State of New Mexico
Energy, Minerals and Natural Resources Department

Form C-103
Revised 1-1-89

WELL API NO.	30-005-60713
5. Indicate Type of Lease	STATE ☒ FEE ☐
6. State Oil & Gas Lease No.	V-1361
7. Lease Name or Unit Agreement Name	Latham State
8. Well No.	1
9. Pool name or Wildcat	Brown Grayburg Queen

SUNDRY NOTICES AND REPORTS ON WELLS (DO NOT USE THIS FORM FOR PROPOSALS TO DRILL OR TO DEEPEN OR PLUG BACK TO A DIFFERENT RESERVOIR. USE "APPLICATION FOR PERMIT" (FORM C-101) FOR SUCH PROPOSALS.)	
1. Type of Well: OIL WELL ☒ GAS WELL ☐ OTHER ☐	
2. Name of Operator YATES PETROLEUM CORPORATION /	
3. Address of Operator 105 South 4th St., Artesia, NM 88210	
4. Well Location Unit Letter P : 330 Feet From The South Line and 330 Feet From The East Line Section 25 Township 10S Range 26E NMPM Chaves County	
10. Elevation (Show whether DF, RKB, RT, GR, etc.) 3705' GR

WELLNAME: Cathlamet State #1 FIELD: Brown (Grayburg - Permian)
 LOCATION: 330'ESL, 330'EEL Sect. 25-10S-26E
 GL: 105' ZERO: _____ AGL: _____ KB: _____
 SPUD DATE: 5-21-80 COMPLETION DATE: 2-6-80
 COMMENTS: Re-Spud 3-26-85
Compl. 3-16-85

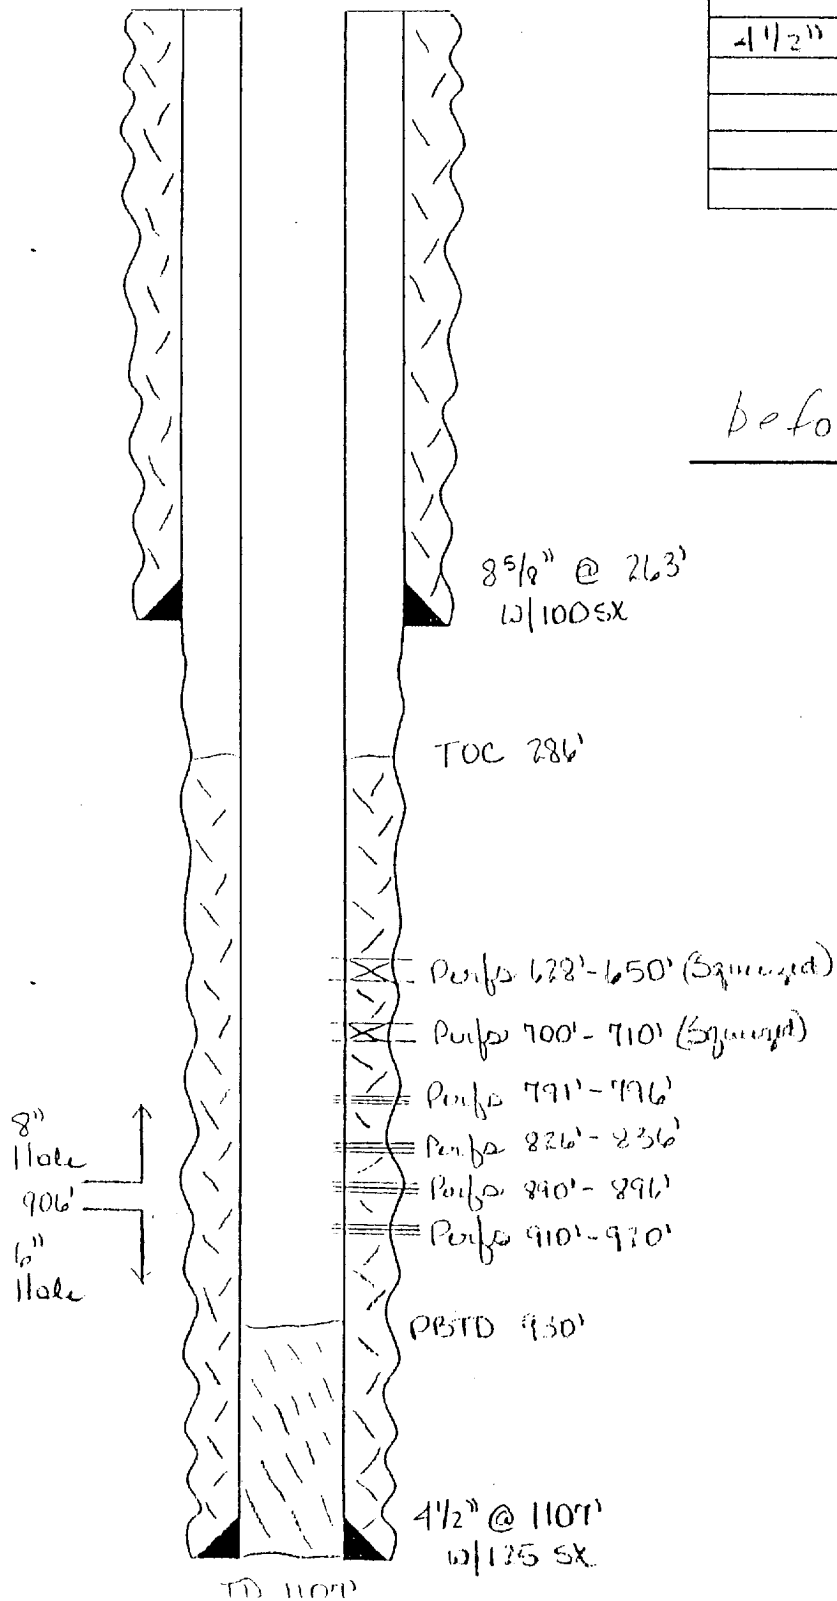
1. Load casing with 2% KCL water. Nipple down wellhead and nipple up BOP. TOOH with rods and tubing. TIH with tubing to PBTD (930'). Spot a 55 sack Class C cement plug from 930-600'. —TA9

2. POOH with tubing to 300'. Spot a ^{100' plug} sack Class C cement plug at the base of the 8-5/8" casing from 300' to surface. 200' - 300' —TA9

Per ES9. @ 85' (Yates) Circ. cmt. to surface - Leave 85' of cmt. inside & outside 4 1/2 csg.
